DRESDEN STATION SPECIAL REPORT NO. 41

QUAD-CITIES STATION SPECIAL REPORT NO. 16

SUPPLEMENT A

"Reactor Building Crane and
Cask Yoke Assembly Modifications"

Figure No. 1.
Typical Cast Handling Cycle

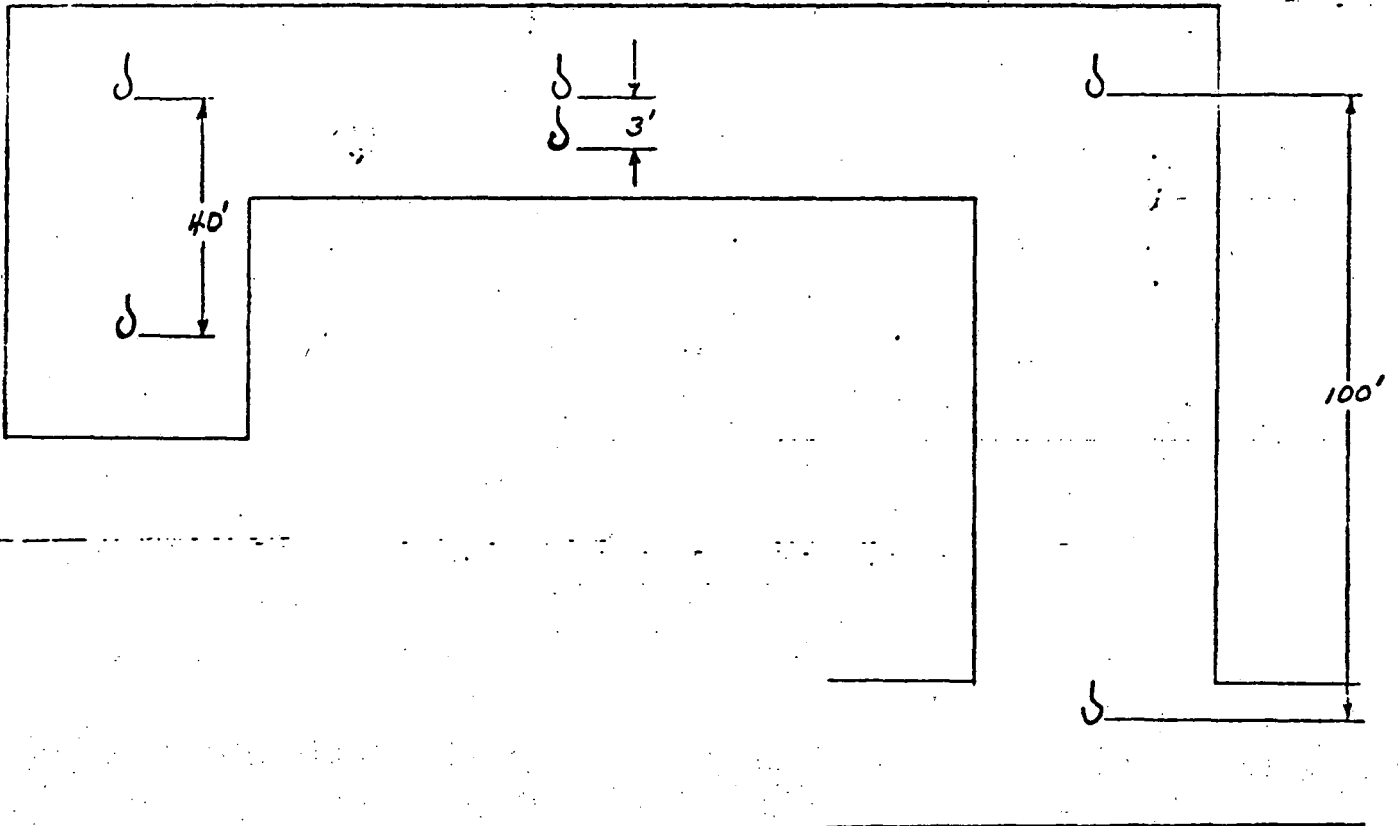
A typical cycle is shown in Figure 1 while a typical reeving diagram is shown in drawings T-53327 and T-53326 (it was assumed all sheaves were the same diameter).

Twenty-four (24) sheaves were determined to be the maximum number of sheaves that a point passes over during one cask handling cycle. The cask handling cycle was assumed to be as shown in Figure 1.

Figure #2

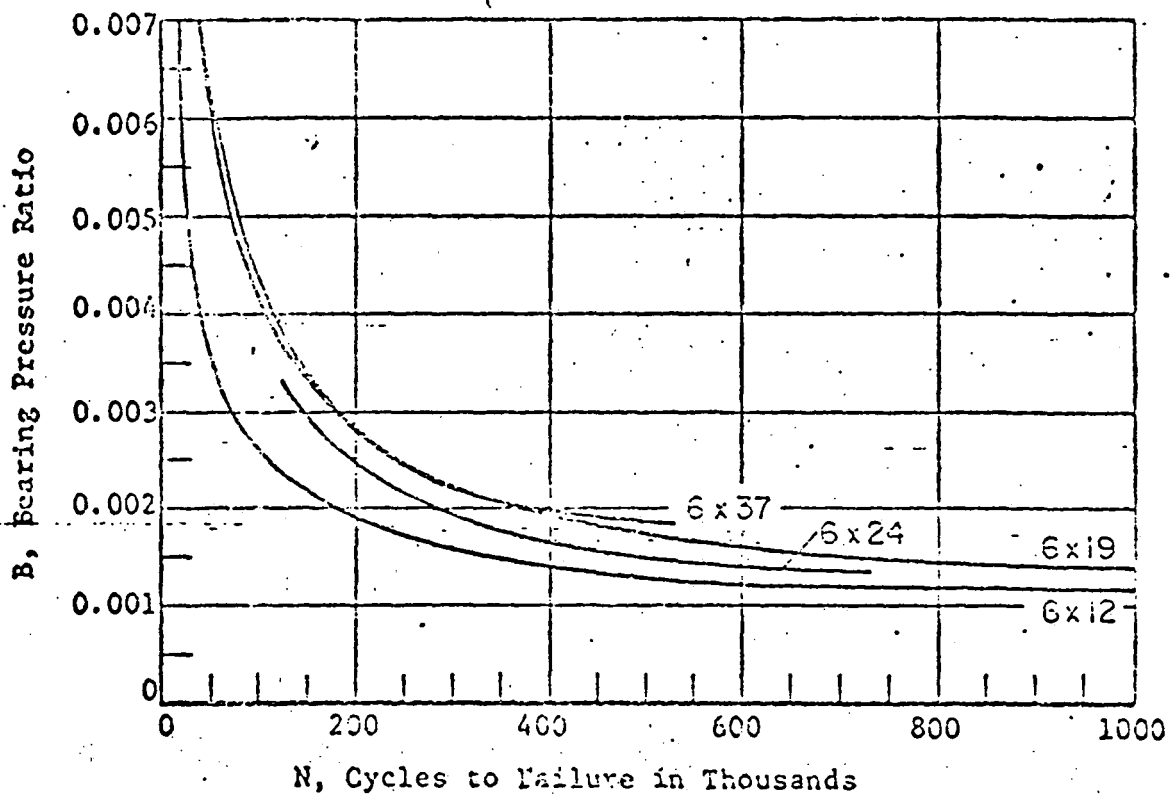
Pressure Ratio vs. Cycles to Failure diagram - Figure #2

From Figure #2

Number of bends to failure - 75,000

T-53327

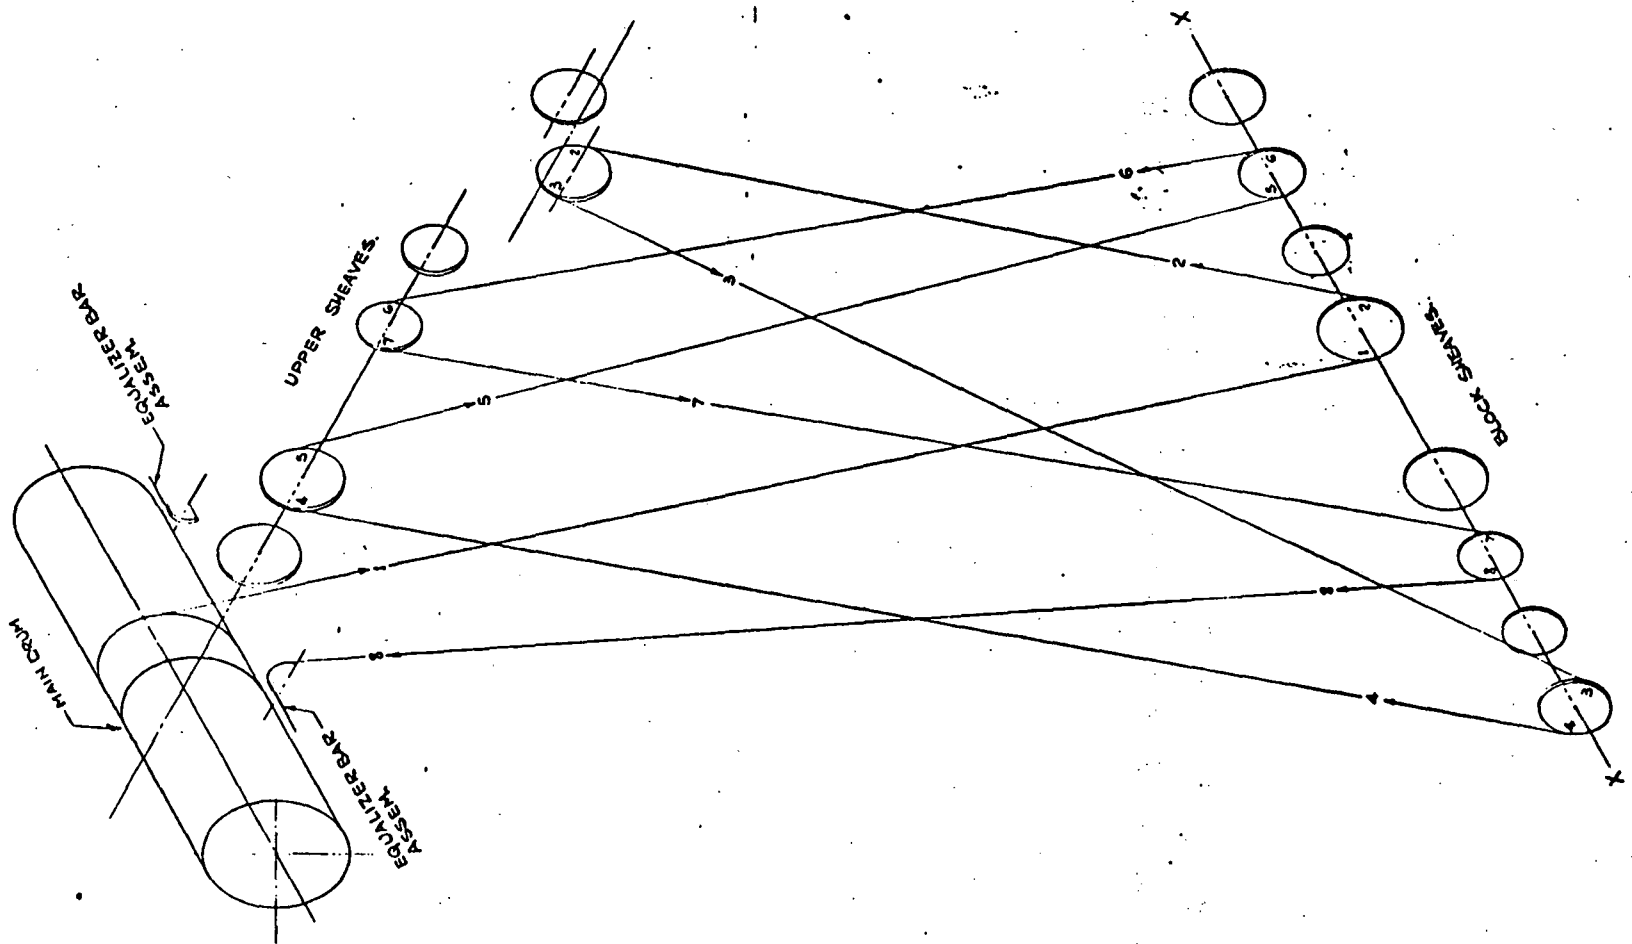
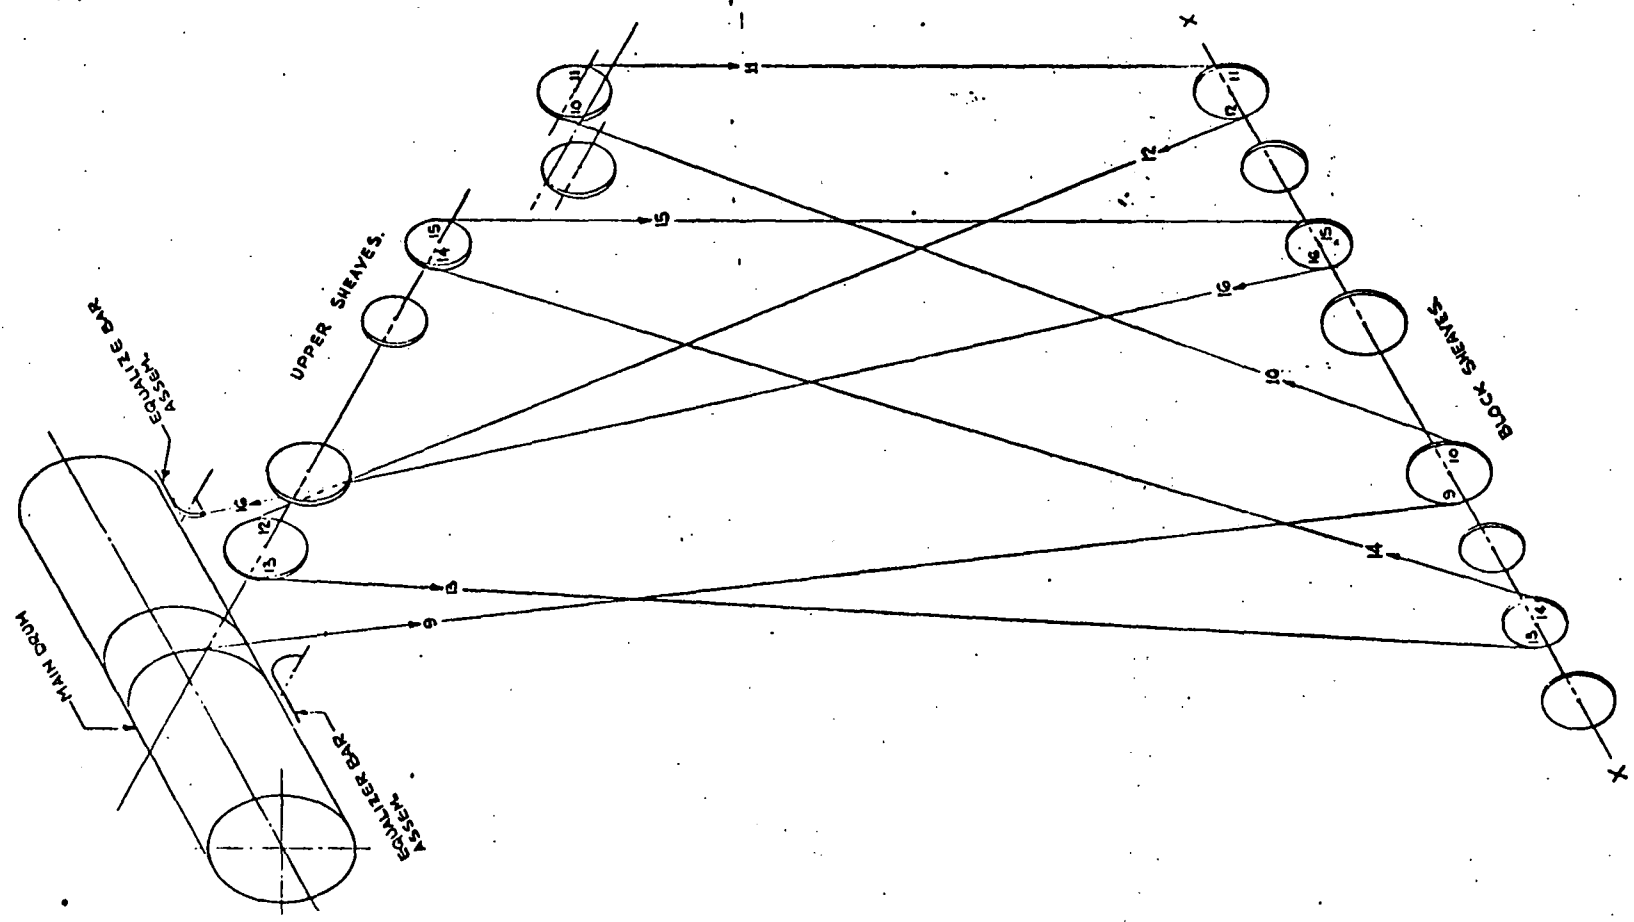
The objective of this section is to show that reverse bending does not exist in the rope except for the lead lines which pass up to the drum, as shown in drawings U-67052, U-67053, T-53326, and T-53327.

Furthermore, as can be seen in U-67053, T-53326, and T-53327 reverse bends are not present since the rope is not changing direction 180° , but only 90° except for the lead lines which pass up to the drum, these lead lines do change direction 180° but the distance is so great that the effect will be negligible (Reference 1 and 2).

REQN	ITEM	QTY	UNIT	DESC	REMARKS	CUSTOMER
8938	10500	1	DRIVE	DRIVER ROLL		WHITING CORPORATION 1000 W. 10th St. CINCINNATI, OHIO
8939	10500	1	DRIVE	DRIVER ROLL		
8940	10500	1	DRIVE	DRIVER ROLL		U-67052
8941	10500	1	DRIVE	DRIVER ROLL

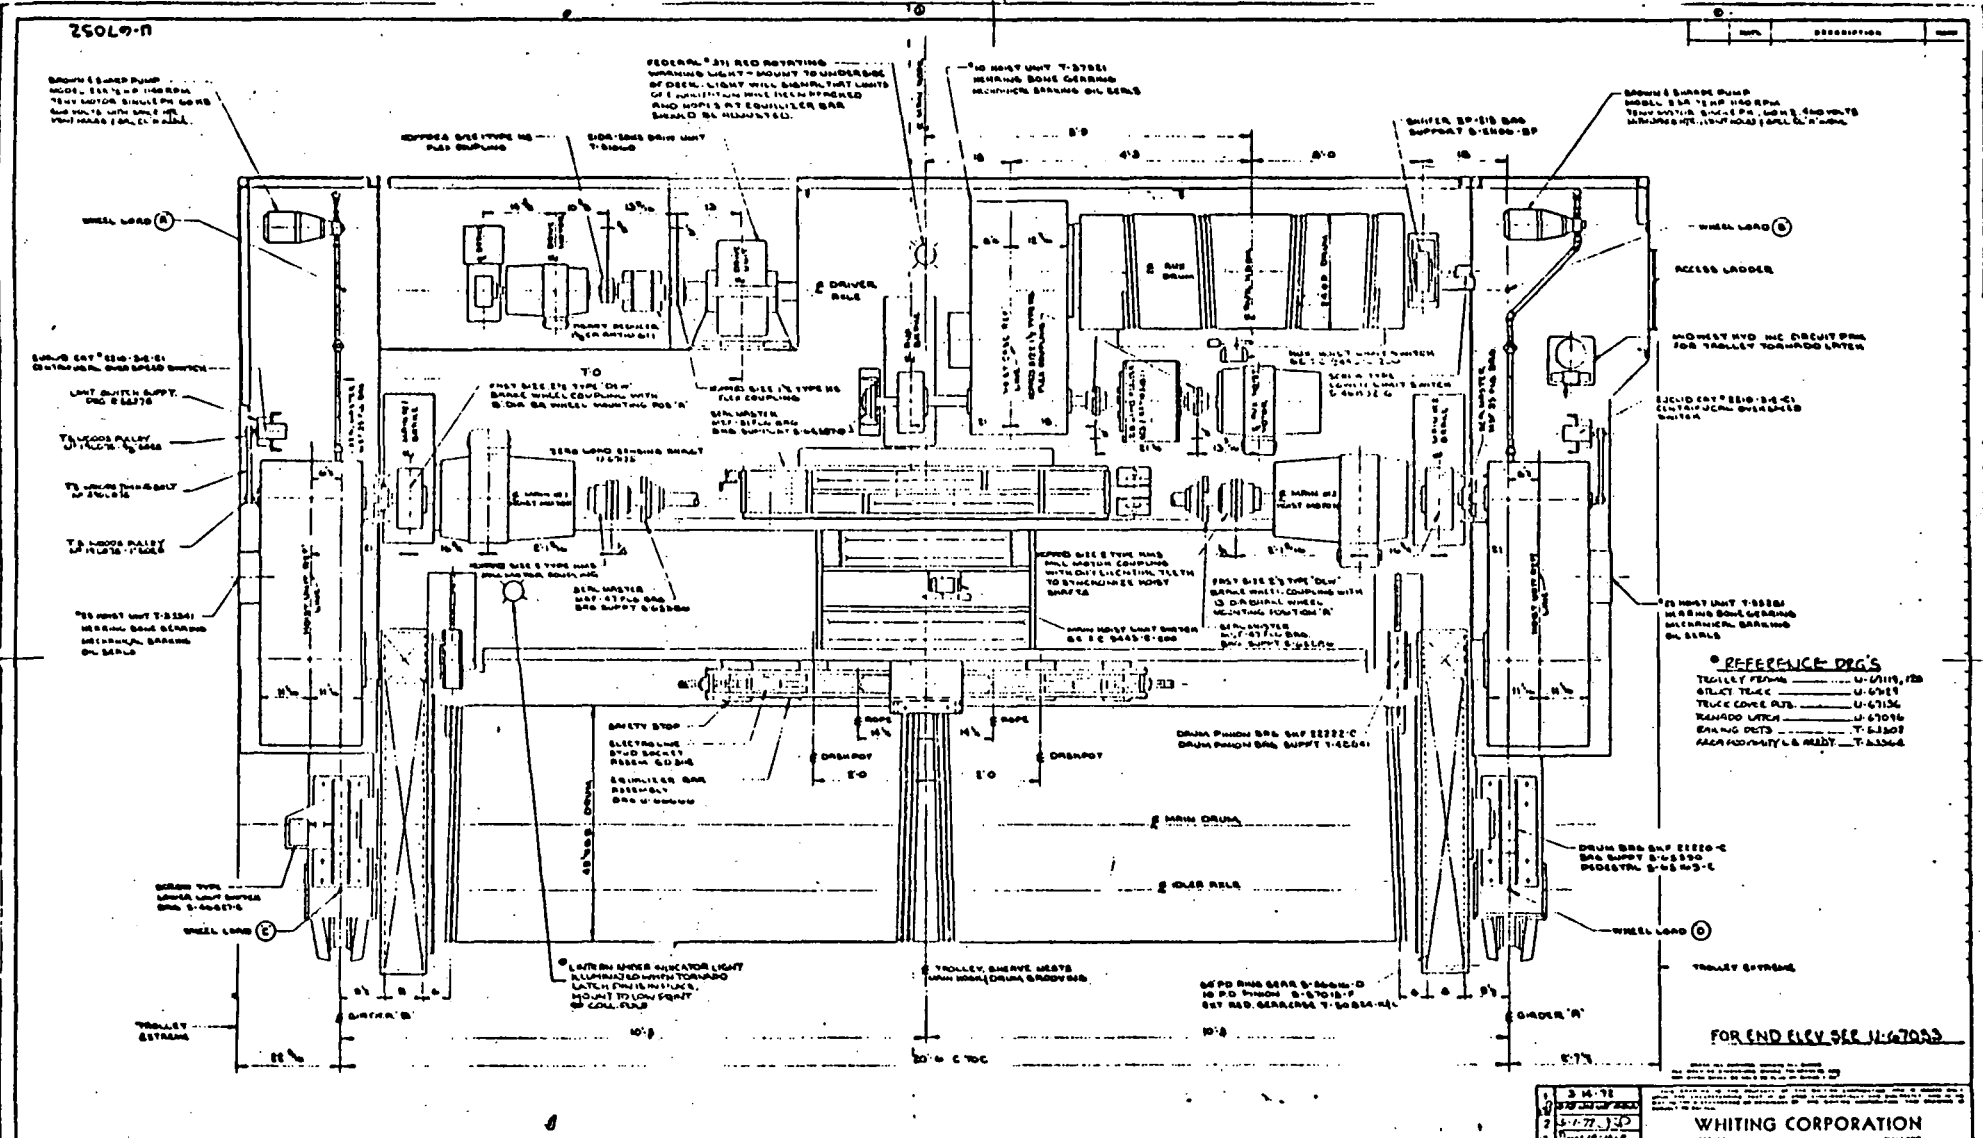
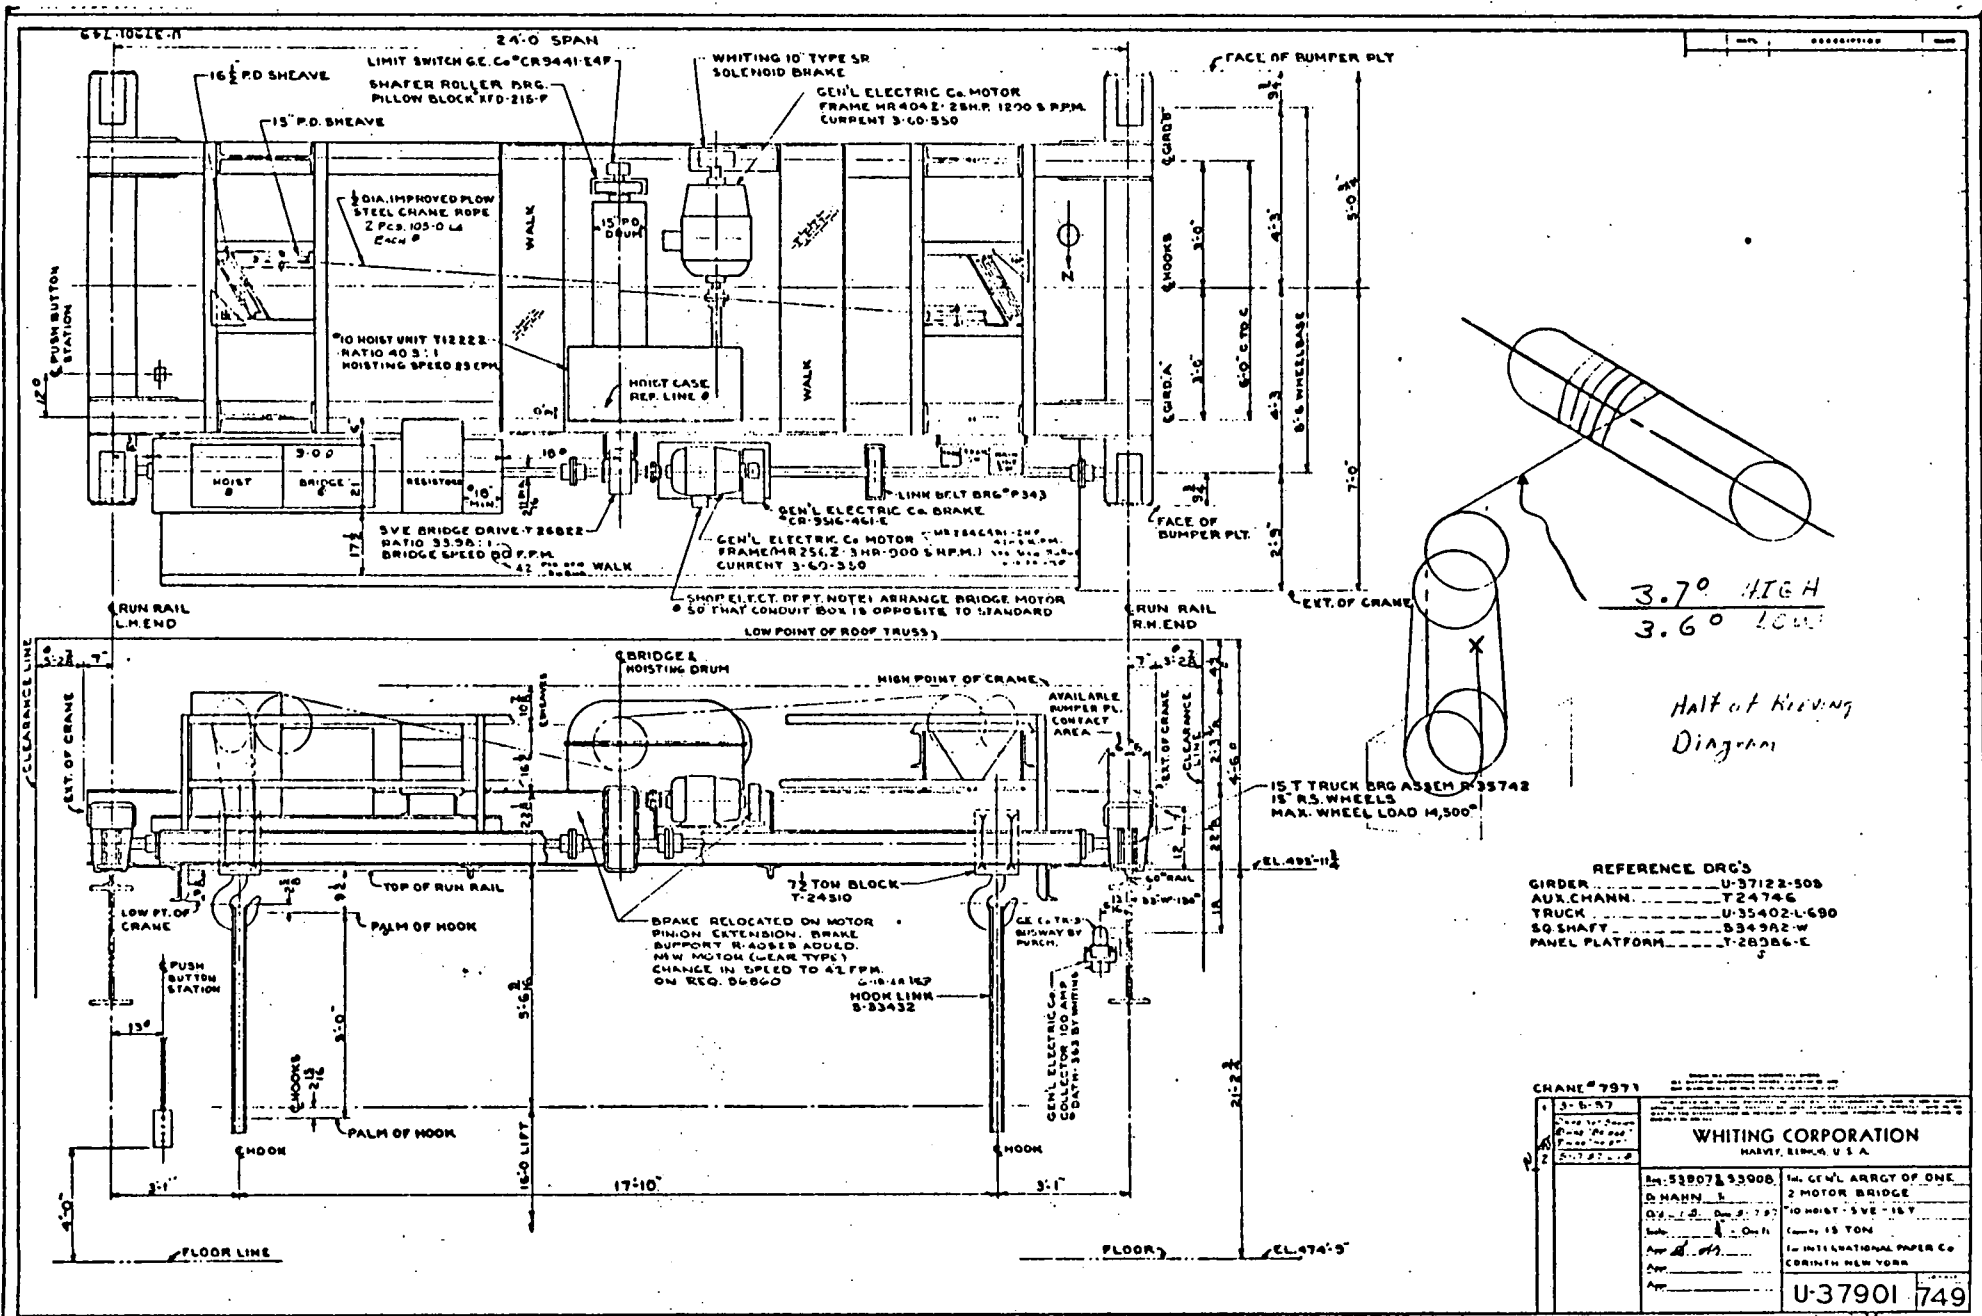
In a typical case the distance from the centerline of the main drum to the centerline of the sheaves in the block (point of tangency) is 9'-4" (112") with the block in the extreme upper position as shown in drawing U-67053. This represents the most severe condition as far as reverse bends are concerned.

A detail analysis (Reference 3) of the change in fleet angle of the lead lines on a typical Redundant Trolley (see drawing U-67053) was made. The original fleet angle based on a 1 to 12 ratio is 4.76° . By the time the drum has turned one revolution, the point of contact on the drum has moved over $1-1/4''$ and the reach has increased from $9'-4''$ to $10.56'$. This reduces the effective fleet angle to 3.64° . The next revolution decreases the fleet angle to 2.75° (Reference 3).

The most important drawing of the set which you sent is U-67053. This drawing shows the traveling block in the extreme up position and thus represents the most severe condition so far as fleet angle and reverse bends are concerned.
